EIA of the Proposed 6000MW
Thermal Power Station at Black
Point: *Initial Assessment Report*

Volume 3 : Operational Phase

**& Response to
Government
Comments**

November 1992

Figure V3/3.4(1)
Annual Average Ground Level Concentration ($\mu\text{g m}^{-3}$) of NO_x Resulting from the Operation of the Proposed Power Station at Black Point and the Existing Power Station at Castle Peak Partial Operational Load - Assuming Non-Flat Terrain

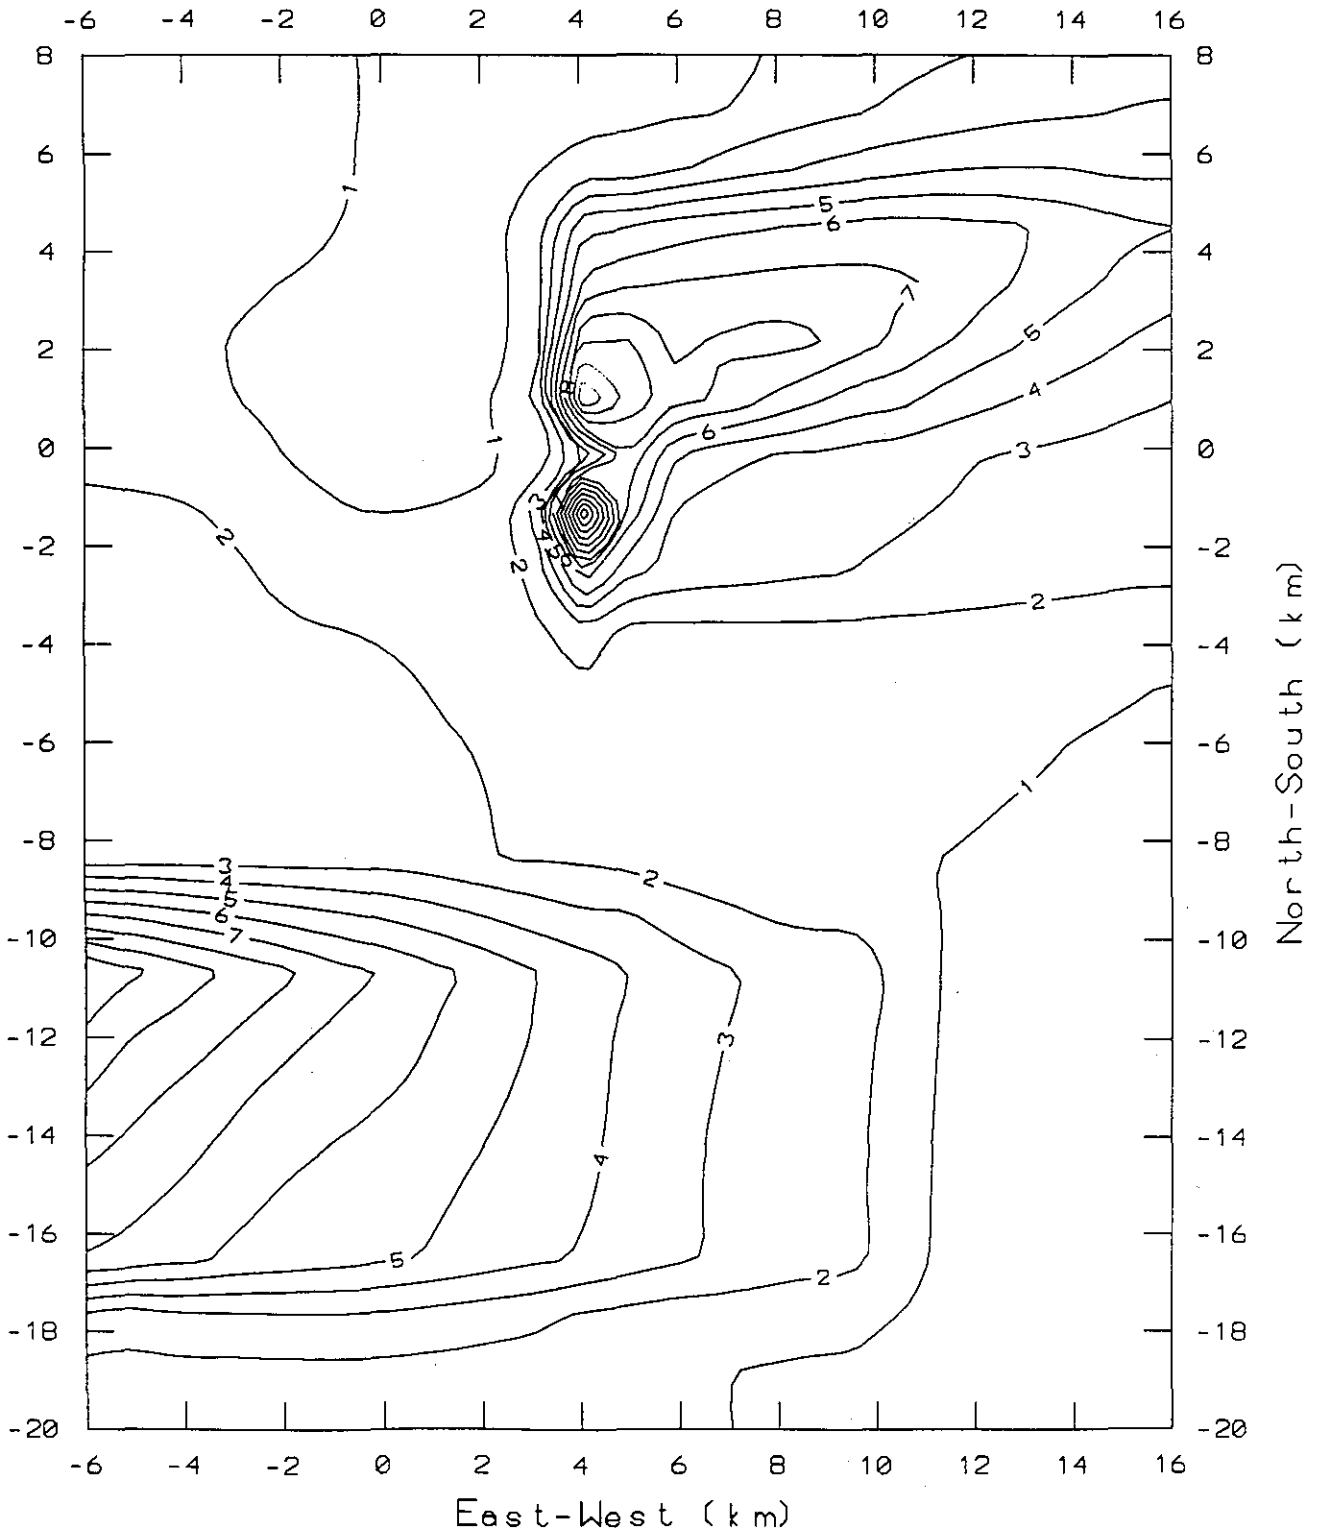
Department	Reference	Comments	Consultants' Responses
	S.3.5	<p>We are surprised that the predictions in Figure V3/3.4 (1) are based on the assumption of non-flat terrain. Please clarify whether all the predictions have catered for the effect of terrain.</p> <p><u>Figure V3/3.4 (m)</u></p> <p>There is a shoulder in the curves at about 1-2 km distance. It is likely that this is contributed by the emission of the combined cycle gas turbines at low level. If this being the case, it would be quite surprising that the both scenarios (viz. 4 coal-fired plants + 4 CCGTs and 8 coal-fired plants) would give rise to similar results. The consultants should make a review.</p> <p>While it is likely that background concentrations at most of the area of concern are low, the Consultants should also note that there are some substantial industrial developments in the northwest N.T. and their emissions may also contribute to the background level, when wind blows westerly. As mentioned in our comments on S.3.3 of Volume 1, more detailed analysis in the Key Issue Report are expected.</p>	<p>This was a security run. The non-flat terrain referred to is simply an idealised plateau at stack height for those areas of Hong Kong which are greater than 250m amsl.</p> <p>The 'shoulder referred to by EPD is an initial peak due to the CCGT's produced by the model. The main peak, due to the CCGT's, in fact occurs at 4-5 km for stability categories B and C, with the maximum being $120 \mu\text{g m}^{-3}$. Addition of these curves to those of 4 coal-fired units at Black Point therefore produces similar concentrations as 8 coal-fired units for Categories B and C. (The lower emissions rates from the CCGT's are balanced by lower stack heights for NOx.)</p> <p>Noted.</p>

Figure V3/3.6(a)
Annual Average Dry Deposition of SO₂ for Scenario I (keq km⁻² yr⁻¹)

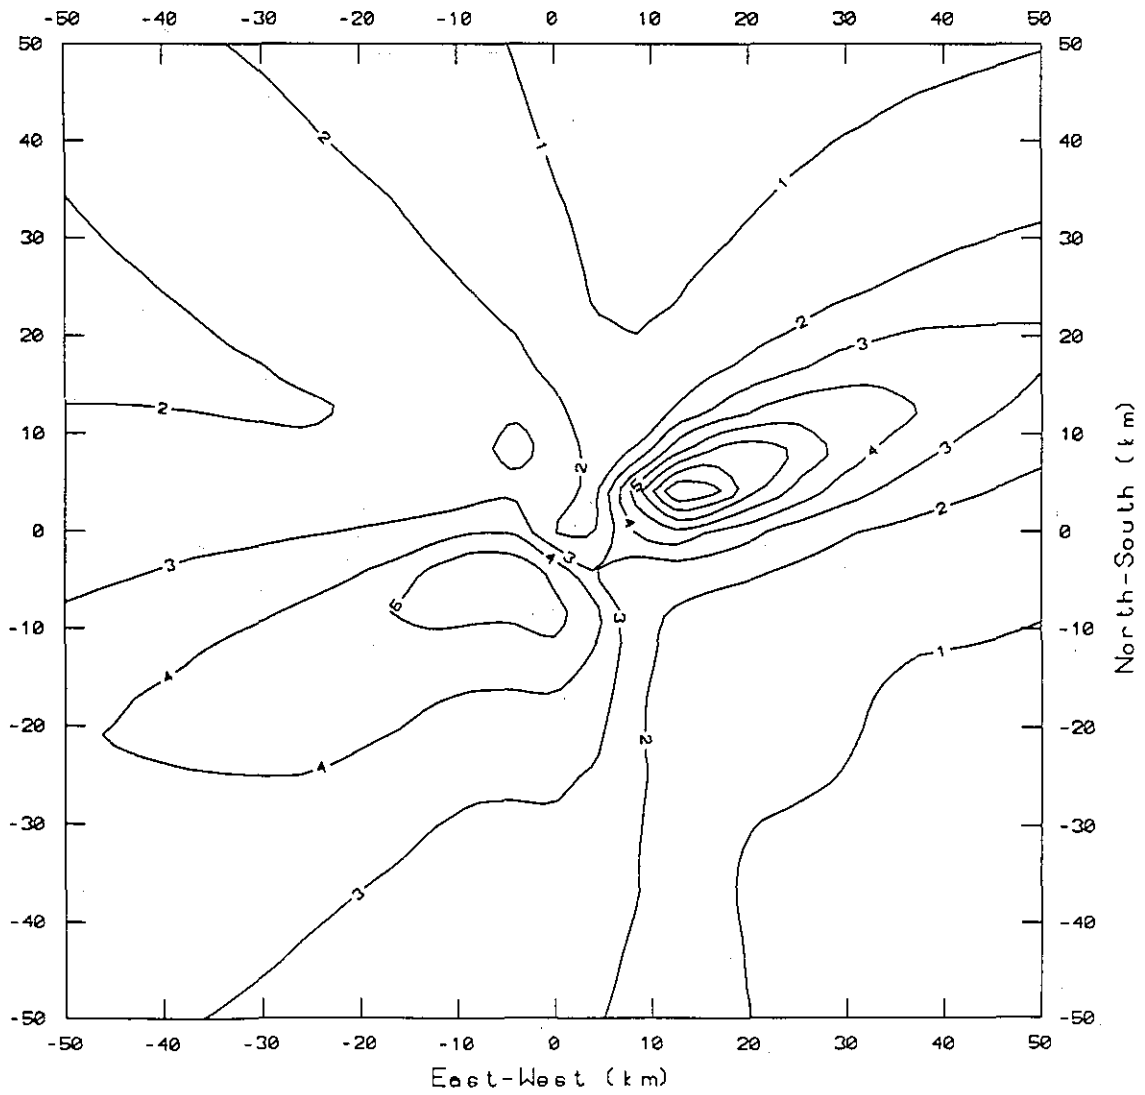
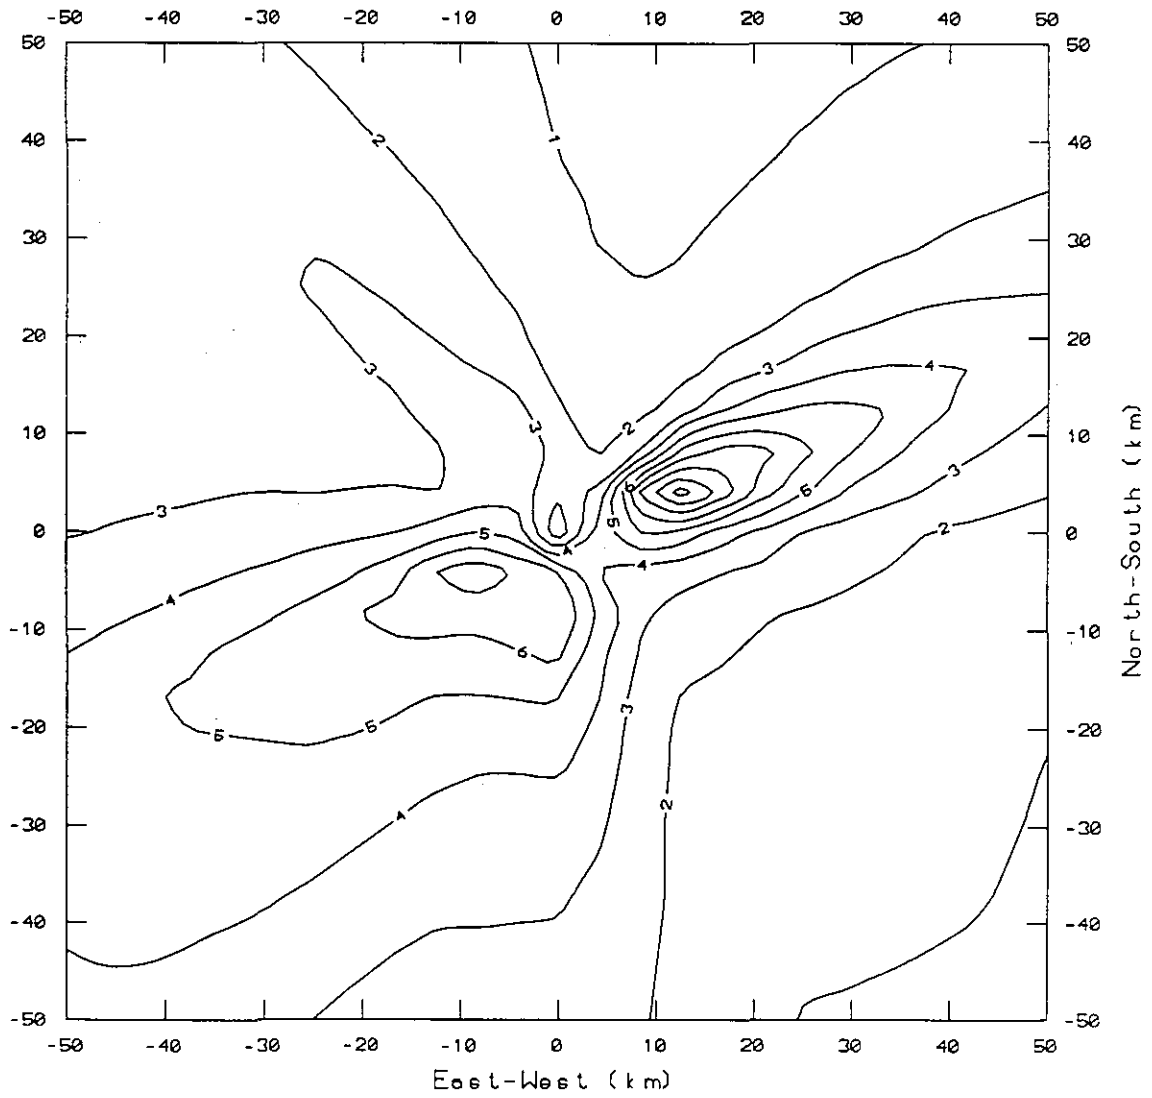
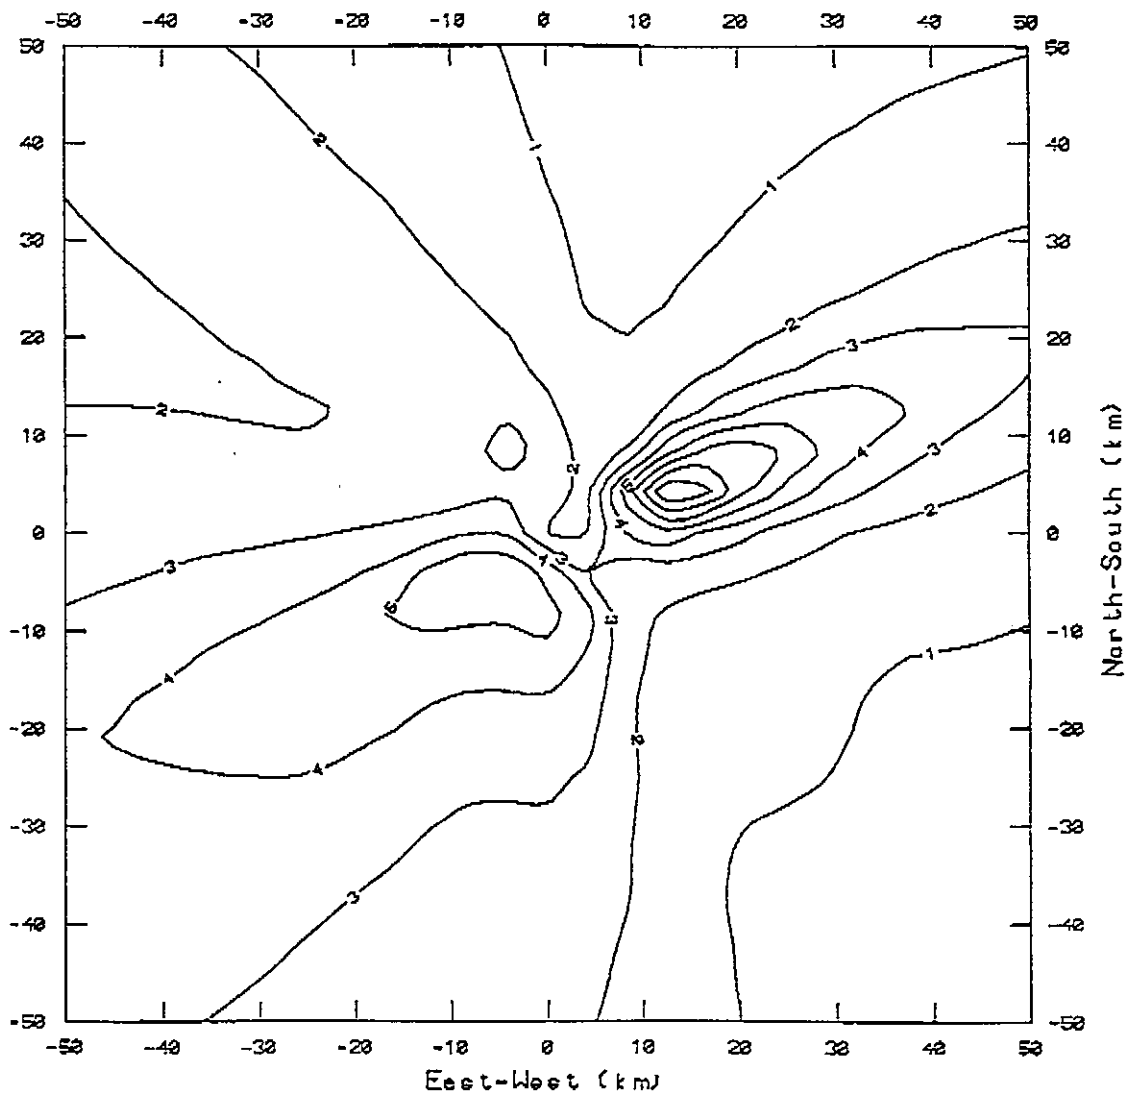
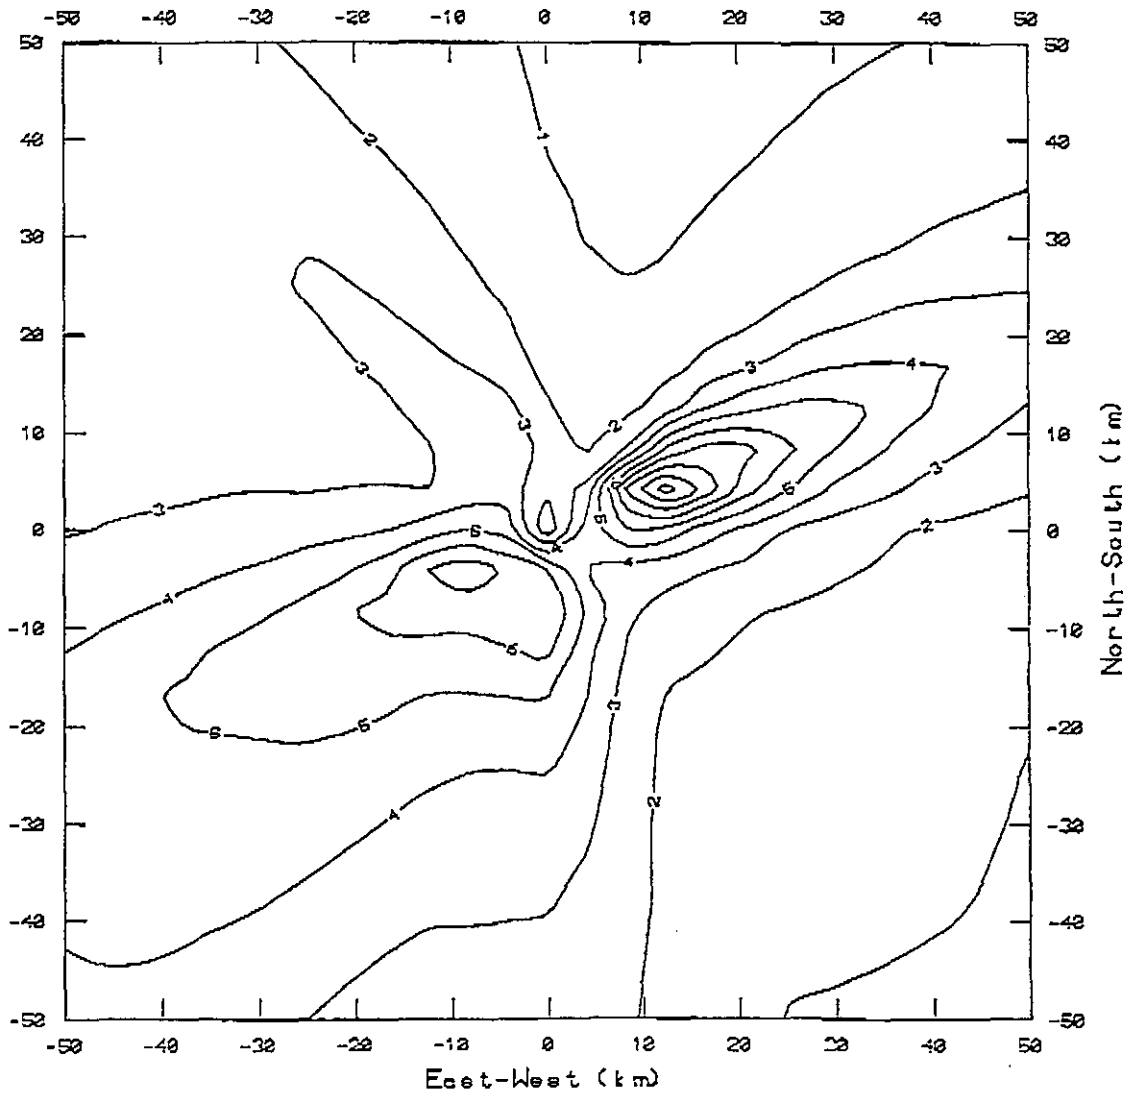
S.3.6.2 (i) (b) on Pg. 78	The dry deposition is assumed to be proportional to the ambient concentration of the acidic gas. The proportional relationship should be given in the report.	Noted and agreed.
	Annex V3/E	Figure 3.6 (a) and (b) are not presented in the report. As such, meaningful comments cannot be made. It is considered more appropriate to agree on the details of the monitoring requirements after the completion of the Key Issue Report.	These will be included in the Final Report Annex C. Noted.
